Subject: MHI's Responses to US-APWR DCD RAI No. 709-5489 Revision 2 (SRP 03.07.01)

Response to Request for Additional Information No. 709-5489,
Revision 2

**US-APWR Design Certification
Mitsubishi Heavy Industries
Docket No. 52-021**

RAI NO.: NO. 709-5489 REVISION 2
SRP SECTION: 03.07.01 – Seismic Design Parameters
APPLICATION SECTION: 3.7.1
DATE OF RAI ISSUE: 3/7/2011

Figure 1

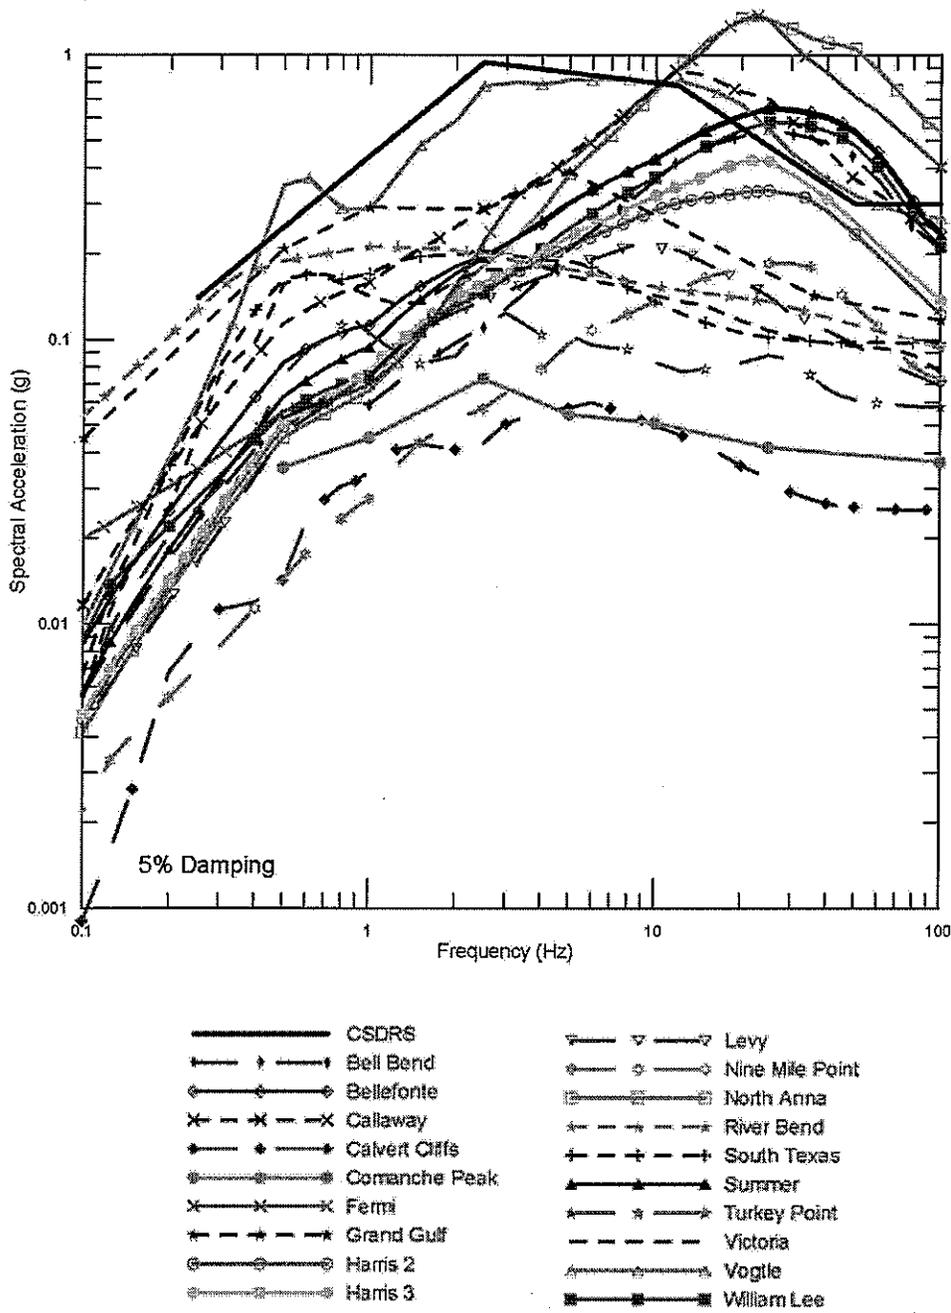
In order to determine whether the requested US-APWR standard design is usable for a multiple number of units or at a multiple number of sites in the United States without reopening or repeating the staff's review, the staff requests that MHI provide quantitative information and details of specific analyses and data developed to support its response to RAI No. 643-4967, Revision 1, (Question NO. 03.07.1-16), dated November 11, 2010, particularly regarding the two statements noted above. The staff also requests that the applicant discuss whether the analysis of the site specific variation for the hard rock sites, where the US-APWR CSDRS does and does not envelope the response spectra characteristic in the high-frequency range, will lead to site-specific variations in the plant designs among plants that reference the US-APWR design. The applicant should also discuss the extent of such variations, as appropriate.

Figure 1 is a comparison of the US-APWR CSDRS with the publicly available ground motion for new plant applications. The graph reflects that of the 19 ground motion curves, eleven curves are bounded by the CSDRS in the high-frequency range. The ground motion for these sites therefore reflects US-APWR compliance with the definition of *Standard Design* in 10 CFR Part 52, whereby the CSDRS "is usable for a multiple number of units or at a multiple number of sites without reopening or repeating the review." Further, DCD Section 3.7.1.1 permits the COL Applicant to perform site-specific soil-structure interaction (SSI) analyses, in which seismic wave transmission incoherence and analysis of the cumulative absolute velocity (CAV) of the ground input motion may be considered. Consideration of incoherence, and/or consideration of the cumulative absolute velocity in the ground input motion, will generally result in reduced seismic demands for those hard rock sites with high-frequency exceedances of the CSDRS.

When the site-specific ground motion for natural frequencies above 10 Hz are determined to exceed the CSDRS (see Figure 1), the design of standard plant structures does not change since the dominant natural frequencies for the standard plant structures, which are the major contributors to the seismic response of the structures, are less than 10 Hz. This conclusion is made since the seismic design for these hard rock sites are bounded by the CSDRS values for natural frequencies less than 10 Hz (the low-frequency outlier is a soft soil site). Similarly, there is no impact to the core internals and fuel rods because the dominant frequencies are also less than 10 Hz. Therefore, the seismic design for the standard plant structures, the core internals and fuel rods are not affected for hard rock sites in CEUS.
